Alabama State Port Authority
Addendum to R&P or Specification Booklet

Project Name ITC Generator – Install Electrical Equipment

Project No. 11210 **Task No.** 5 **Addendum No.** 2

INTERNATIONAL TRADE CENTER GENERATOR
REPLACEMENT (PROJECT #11210)
MOBILE ALABAMA

SHEET TITLE:
 ELECTRICAL EXISTING SUBSTATION POWER PLAN

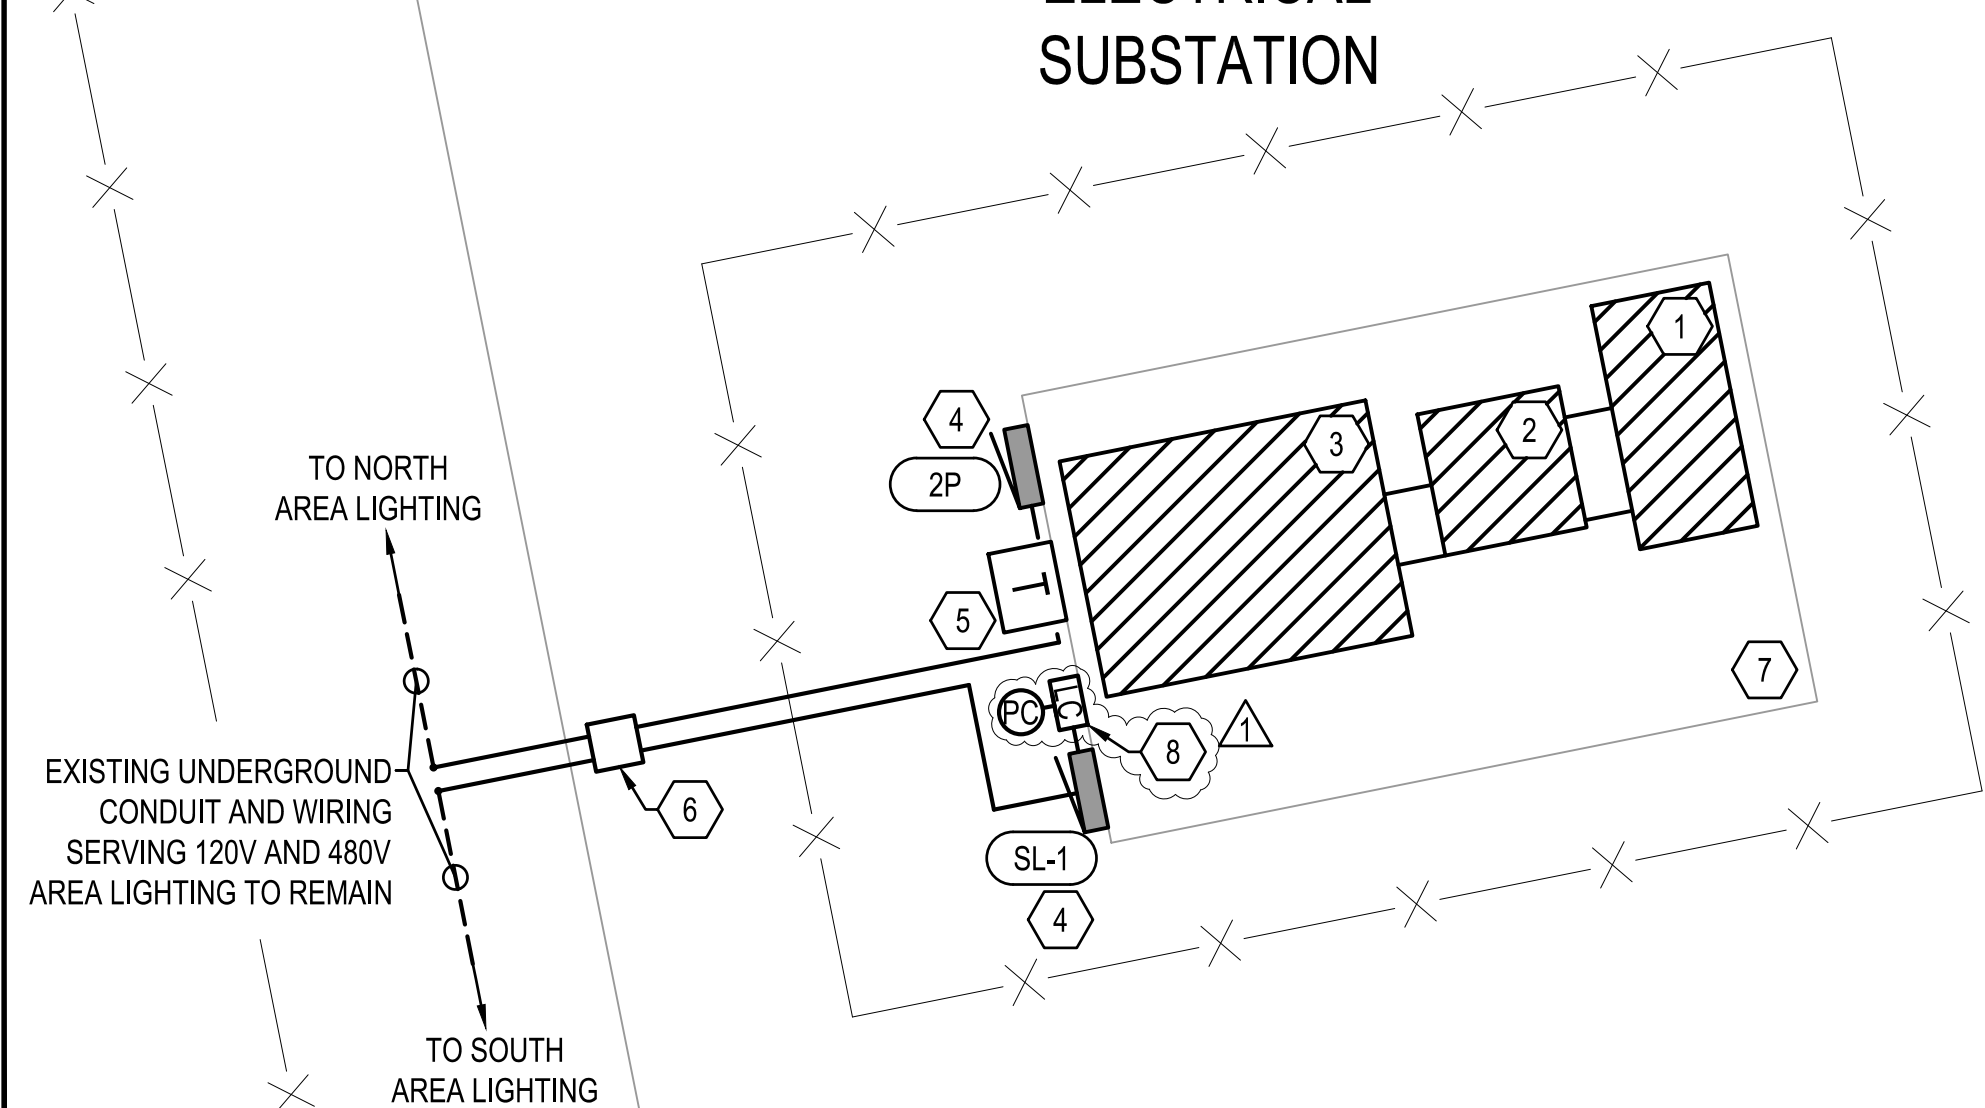
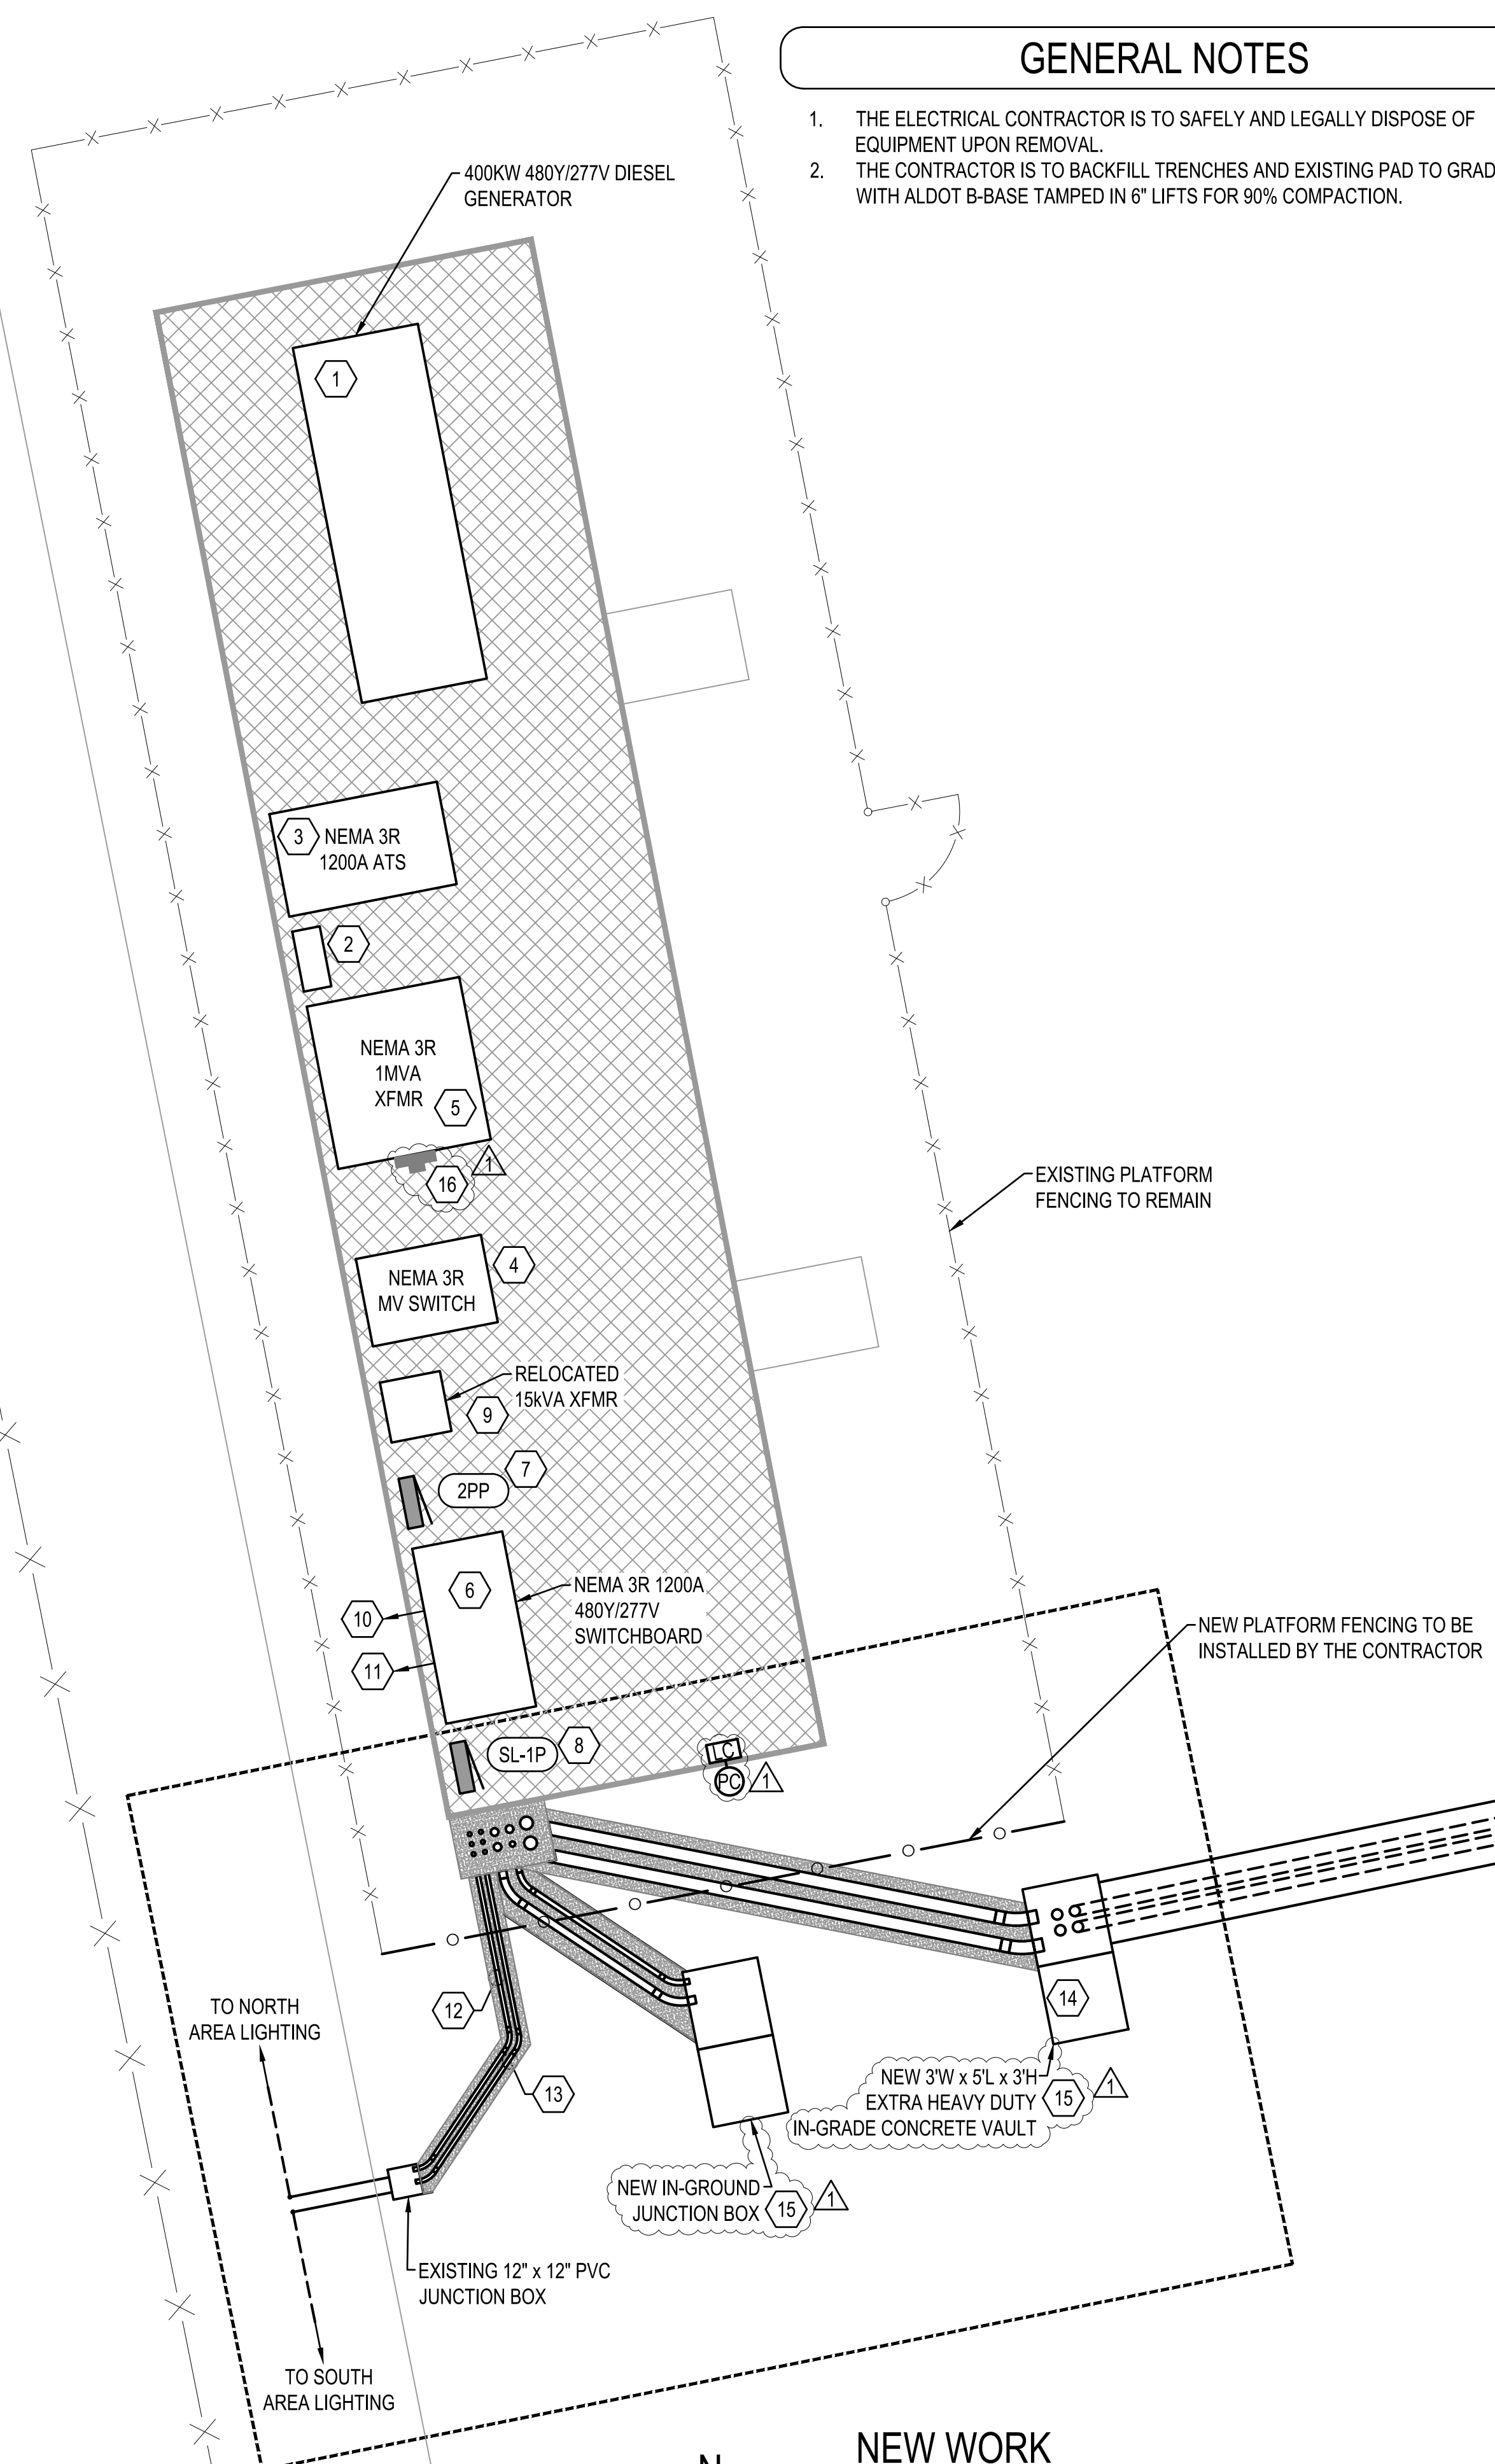
2.	The top of the new in-ground vault and junction box are to be installed 3” above the nearest adjacent concrete curb. Contractor to fill existing pit with ALDOT B-Base, sloped away from the top of the in-ground boxes to match grade of adjacent curb. The contractor is to repair the area of damaged concrete curb in order to retain gravel to match grade. See Sheet E3.1 General Note 2.

3.	Relocate Lighting Switch – the Contractor should relocate the existing security lighting switch from the existing SL-1 panel to the new SL-1P panel. The contractor should furnish and install a new photocell on the relocated lighting switch.

4.	The contractor is to provide and install a new CT Meter on the service transformer secondary. Install 1¼-inch conduit and wiring as specified by the manufacturer to monitor the new service.

6.	The following Sheets have been revised and are included in this Addendum, see Revisions: Sheet E1.1 Sheet E3.1

- 15 THE NEW IN-GROUND JUNCTION BOX AND CONCRETE VAULT ARE TO BE INSTALLED 3" ABOVE THE NEAREST ADJACENT CURB TO THE TOP OF THE BOX TO ALLOW FOR A SLOPED GRADE TO THE ENCLOSURE.

- 16 THE ELECTRICAL CONTRACTOR IS TO PROVIDE AND INSTALL A NEW CT METER ON THE SERVICE TRANSFORMER (WIRING TO BE AS SPECIFIED BY THE MANUFACTURER AND 1 1/4" CONDUIT, IF NECESSARY).
